From: Dave Seller
Sent: Friday, February 2, 2024 8:52 AM
To: Craig Dumart
Subject: OPA/ZBA comments: 236-264 Victoria Street North

Application Type: Official Plan Amendment Application OPA24/001/V/CD
Zoning By-law Amendment Application ZBA24/001/V/CD

Project Address: 236-264 Victoria Street North

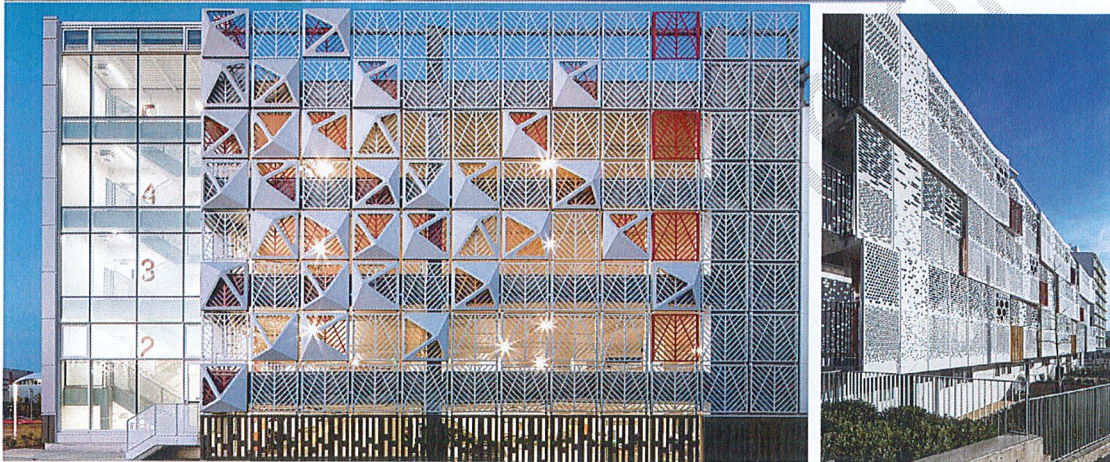
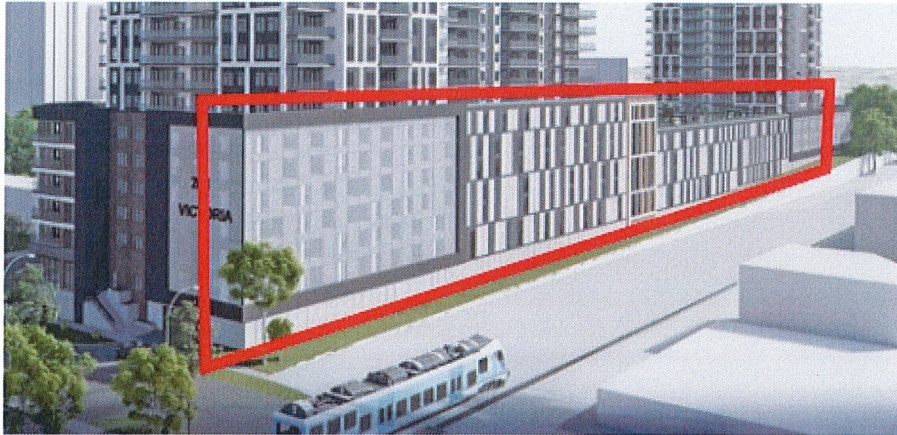
- The proposed retaining wall along Victoria Street doesn't contribute positively to the streetscape. To enhance the overall design and create a more appealing pedestrian view, we suggest bringing down the retail floor to level it up with the street. This adjustment not only addresses the streetscape concern but also provides an opportunity to increase the height of the retail space, accommodating a mezzanine level. This will offer a more engaging and visually pleasing interface for pedestrians.

- Additional design modifications for the proposed exposed structure parking should be provided. You may consider incorporating some advanced detailing for the proposed cladding for the structure parking as it is highly exposed from St. Leger Street.

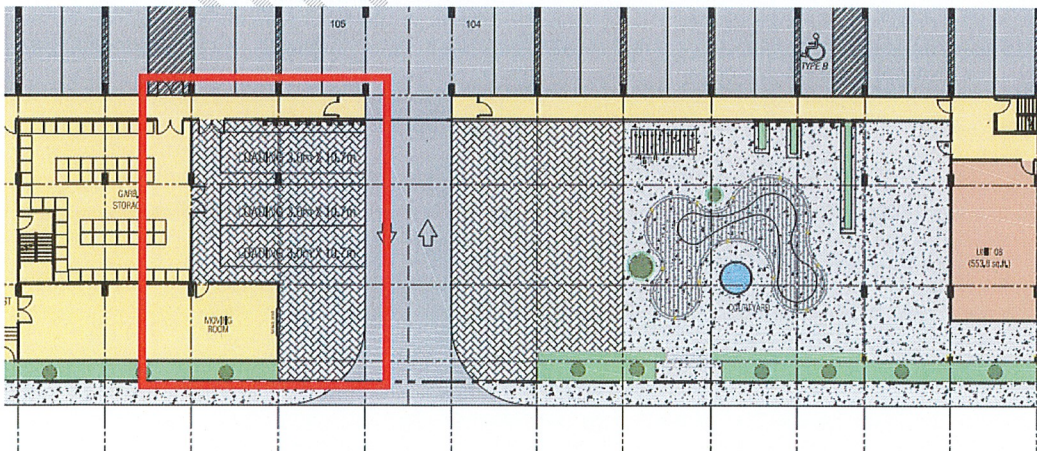
- Active uses, including retails with outdoor patios or residential amenity areas, should be situated along Victoria Street and the proposed central outdoor public plaza.
- The proposed loading area facing the outdoor amenity space does not contribute positively as it is highly exposed to the public realm. The proposed loading area should be relocated more internally to the site. Please see the attached precedent images
